# Wisconsin Department of Transportation

### NOTICE TO ALL CONTRACTORS:

**Proposal #24: 4616-03-71, WISC 2021092**  
**T Wrightstown, CTH ZZ**  
**Clay Street – Mallard Road**  
**CTH ZZ**  
**Brown County**

This is Addendum No. 02, which provides for the following:

Addendum No. 02  
ID 4616-03-71  
Revised Sheet 81  
December 24, 2020

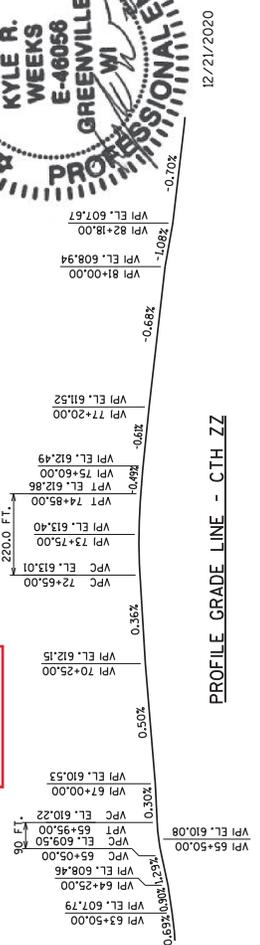
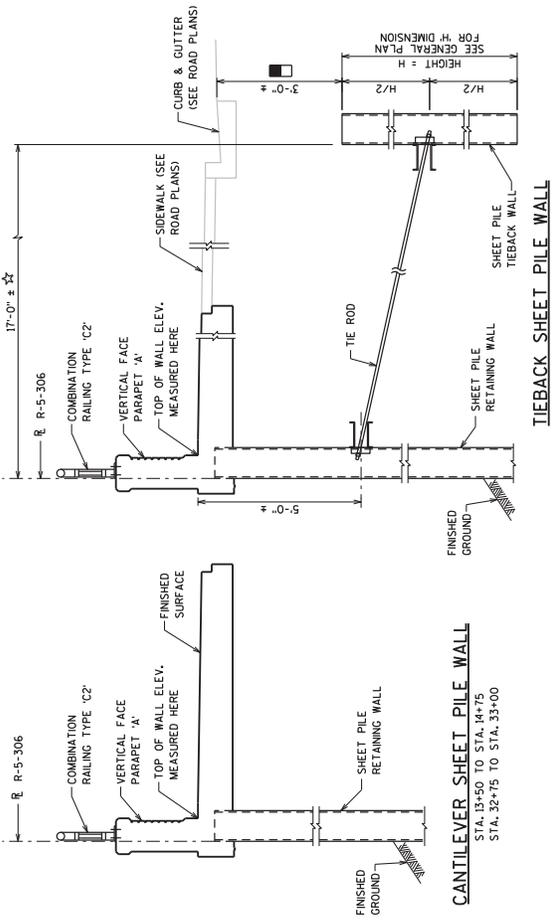
<b>Revised Plan Sheets</b>	
<b>Plan Sheet</b>	<b>Plan Sheet Title (brief description of changes to sheet)</b>
81	Wall Details R-5-306 Sheet 3 of 12 – updated quantities, modified general notes
83	Anchor Slab Details R-5-306 Sheet 5 of 12 – updated detail/notes for backfill limits
85	Parapet and Aesthetics Sheet 7 of 12 – updated legend

ANCHOR SLAB DETAILS

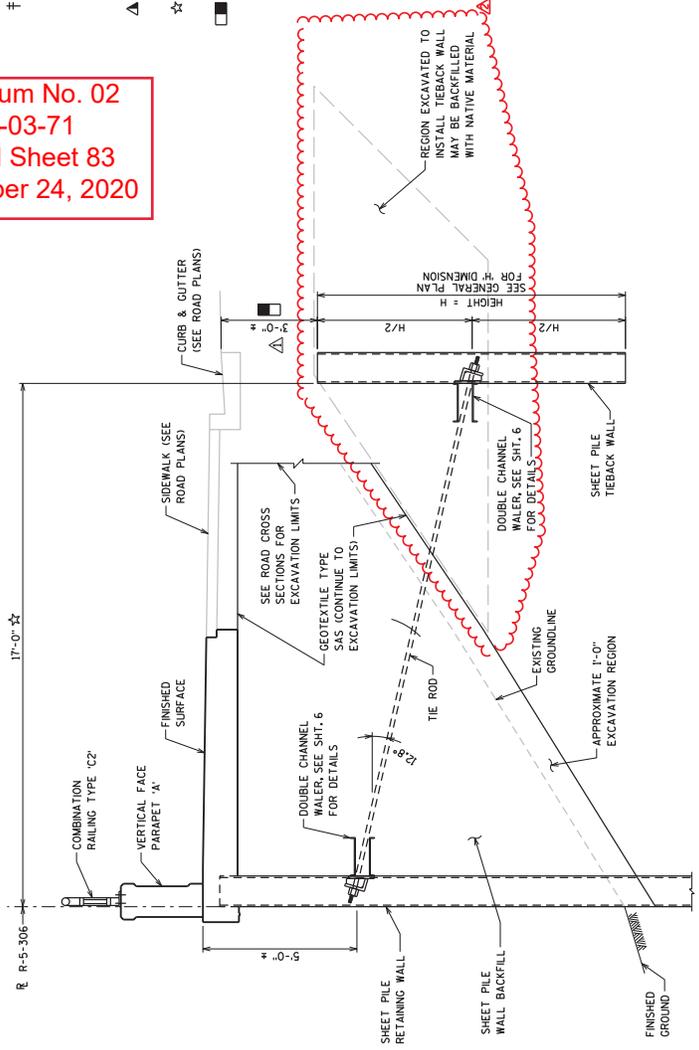
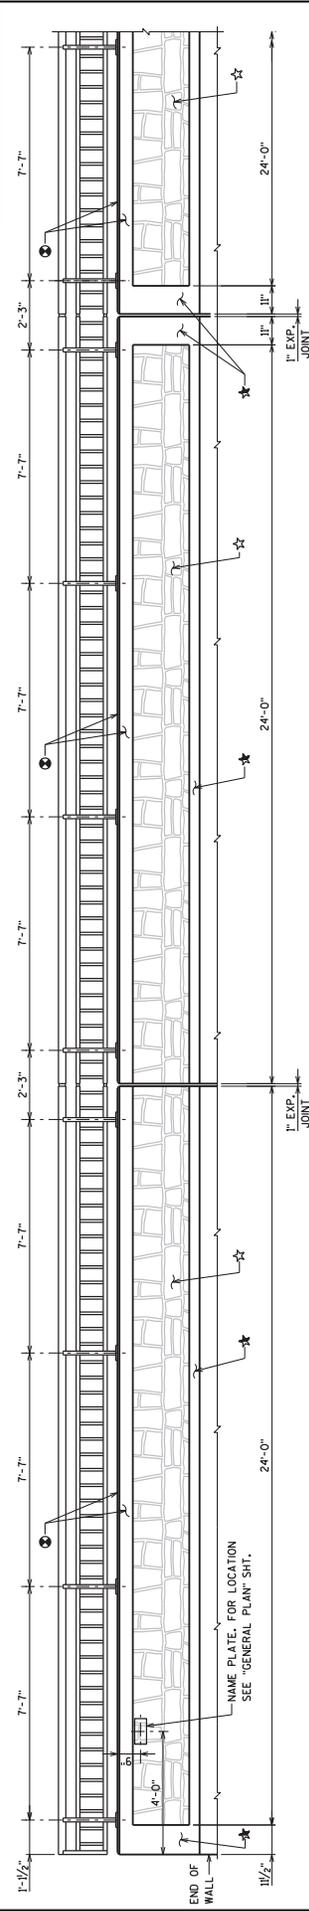
NO.	DATE	ADDED BACKFILL	NOTE	BY
2	12/21/20			BRE

LEGEND

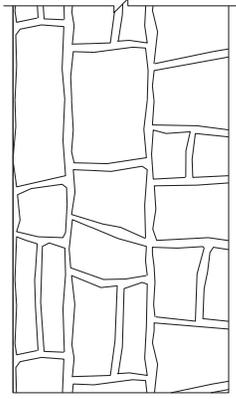
2	12/22/20	ADDED NOTE & SYMBOL	BRE
		REVISION	BY
STATE OF WISCONSIN DEPARTMENT OF TRANSPORTATION			
STRUCTURE R-5-306			
	BY	DATE	
	BRN	12/22/20	KRO
SHEET 7 OF 12			
85

- ④ PIGMENTED SURFACE SEALER
- ⑤ PROTECTIVE SURFACE TREATMENT
- ☆ "ARCHITECTURAL SURFACE TREATMENT" AND "CONCRETE STAINING MULTI-COLOR" MATCH B-5-381 5TH 96 OVER THE FOX RIVER.
- ★ "CONCRETE STAINING" REDD FEDERAL COLOR NO. 33522
